**FINAL FINDINGS, CONCLUSIONS AND DECISION OF THE
 HISTORIC LANDMARKS COMMISSION
 ON AN
 APPEALED ADMINISTRATIVE DECISION
 (TYPE II PROCEDURE)**

Case File Number: LU 21-072667 HRM – Addition to House & Garage & New Driveway

Site Address: 2239 NE 19TH AVE

C32

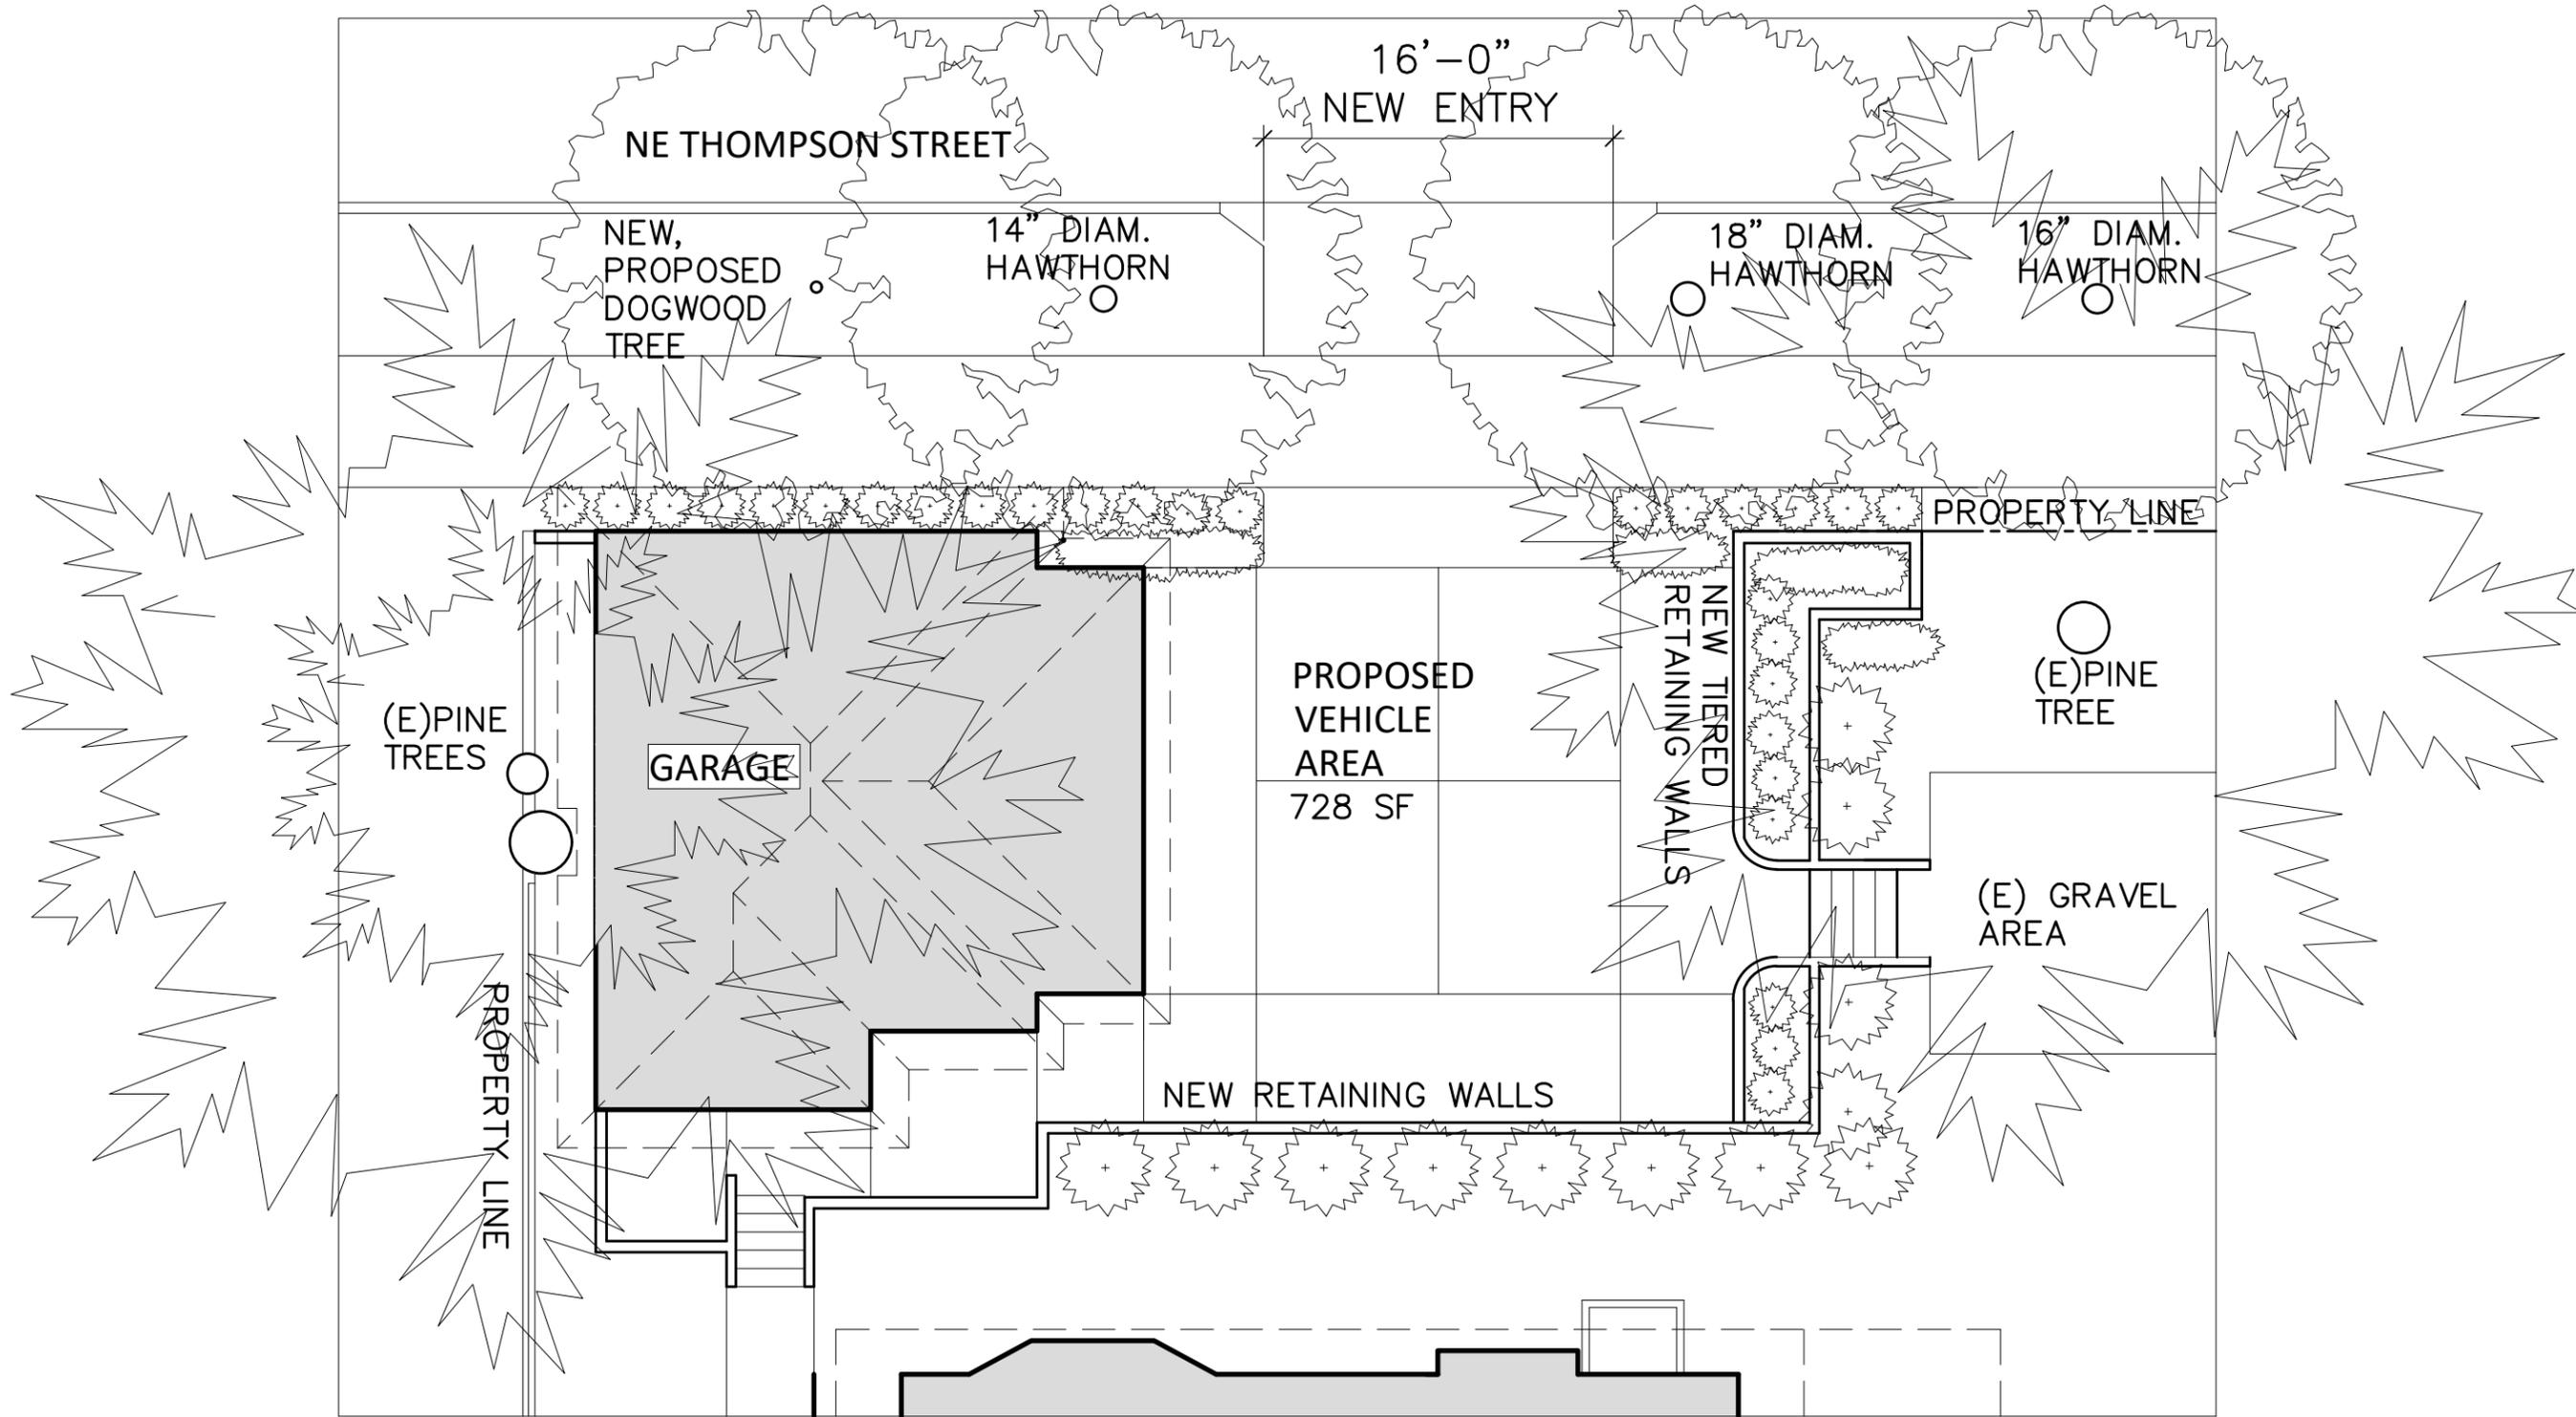
The applicant has submitted two site plans for the proposed vehicle area. The applicant's preferred site plan (sheet A6) has a 20-foot-wide driveway at the property line. This substantially exceeds the minimum residential driveway width of 9-feet that is required by Title 33. Narrow driveways as they cross the property line and sidewalk serve numerous objectives: to slow vehicles crossing the pedestrian sidewalk and entering traffic, to ensure vehicles are traveling perpendicular to the sidewalk as they cross over it so drivers can see in both directions, and to deter parking that impedes with pedestrian travel on the sidewalk. The Title 33 standards apply only to the driveway and vehicle area on-site. The Portland Bureau of Transportation reviews and approves applications for driveways as they cross the public right-of-way between the property line and the street curb.

Staff requested an alternative site plan that narrowed the driveway at the property line by the sidewalk to a maximum of 10-feet, while still allowing the vehicle area to the south for turning into and out of the garage. The intent of the staff request was to reduce the gap in the existing concrete retaining wall at the property line, decreasing the visibility of the new vehicle area while maintaining the safety of the pedestrian realm by ensuring vehicles crossing the sidewalk are traveling slowly and have maximum visibility. The applicant has provided a narrower driveway option on sheets A6, A7 & A8. This option, with the ten-foot driveway at the property line abutting the sidewalk maintains the consistent appearance of the concrete retaining wall as viewed from the sidewalk, and partially screens the new at-grade vehicle parking area and exposed, enlarged garage sidewall. Of the two options, this one better meets the guidelines, as it reduces the visual impact of the proposed changes and maintains a more consistent street wall abutting the sidewalk. This option also addresses concerns raised by the Irvington Community Association.

Therefore, with the Condition of Approval C that the site plan and street elevation shall reflect the maximum 10'-foot driveway throat width shown on sheets C27 & C28 these guidelines are met.
